Access Compliance Report Public Rights-of-Way (Curb Ramps)

Main Street: SANBERT_ST Cross Street: LYMAN_AVE Location: NE

ADA ID: RPAT211112095204 Ramp Type: Type 1 - Perpendicular Diagonal Initial Pass/Fail: Pass Overall Compliance: No Severity Score: 7

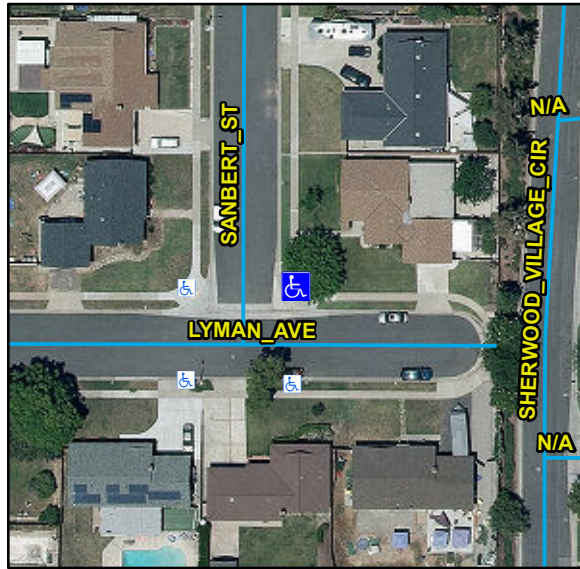
Compliance	Description	Data	Compliance	Description	Data
N/A	Ramp Length (in)	55	N/A	Flare Type LT	
Yes	Ramp Width (in)	48			Sloped
Yes	Ramp Run Slope (%)	7.2	N/A	Flare Slope LT (%)	7.9
No	Ramp Cross Slope (%)	2.6	N/A	Flare Traversable LT	No
N/A	Landing Present	Yes	N/A	Flare Type RT	
N/A	Landing Length (in)	54			Sloped
Yes	Landing Width (in)	48	N/A	Flare Slope RT (%)	2
Yes	Landing Run Slope (%)	1.9	N/A	Flare Traversable RT	No
No	Landing Cross Slope (%)	2.2	Yes	DWS Provided	Yes
N/A	Landing Movement Obstructed?	Yes	Yes	DWS Contrast	Yes
	Landing Movement Type	Curb	Yes	DWS Length (in)	36
N/A	Landing Shared	No	Yes	DWS Full Width	Yes
N/A	Clear Space	Yes	Yes	DWS Offset Left (in)	0
N/A	Clear Space To Crosswalk (in)	48	Yes	DWS Offset Right (in)	N/A
N/A	Marked Crosswalk 1	No	N/A	Marked Crosswalk 2	No
	Crossing 1 Direction	W		Crossing 2 Direction	S
	Marked Crosswalk 1 Width (in)	N/A		Marked Crosswalk 2 Width (in)	N/A

N/A	Ramp Inside Crosswalk 1	N/A	Yes	Ramp Inside Crosswalk 2	N/A
	Crossing 1 Slope (%)	1.2		Crossing 2 Slope (%)	6.2
	Crossing 1 Cross Slope (%)	4.4		Crossing 2 Cross Slope (%)	0.2
Yes	Gutter Ponding	No	No	Curb Slope	6.8
Yes	Gutter Lip Height (in)	0		Road Run Slope (%)	2
No	Gutter Run Slope (%)	6.3		Road Cross Slope (%)	2.6
No	Gutter Cross Slope (%)	4.1			
Yes	Overall Surface Condition: Acceptable		Yes	Perp Joint Present	Yes
	Cross Gutter Present?	Yes		Spandrel Present?	Yes
	Replace Cross Gutter?	No		Replace Spandrel?	No

Remove & Replace Curb Ramp With Two New Directional Ramps or Equivalent. Remove & Replace Gutter.
